FIELD SERVICE BULLETIN

FSB Number: LVCCFSB2005-298
Authors: Darwin Garcia
Date: September 26, 2005
Total No. of Pages: 2
Subject: **V3 K-Flex 40 Pin Connector Engagement**
Model Affected: **V3**
Level of Repair: 3

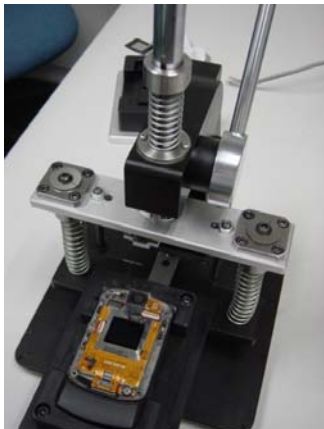
Service has been made aware of a V3 K-Flex 40 Pin Connector Engagement issue causing “No Display, and No Side key Function” complaints.

The root cause was determined to be the 40 Pin connector not being fully engaged during assembly at the factory.

The assembly process for the 40 pin connector was improved by adding a new assembly fixture to ensure correct mating on September 16 2005.

When servicing any V3 customer phones with described issue, the K-Flex 40 pin connector must be re-engaged.
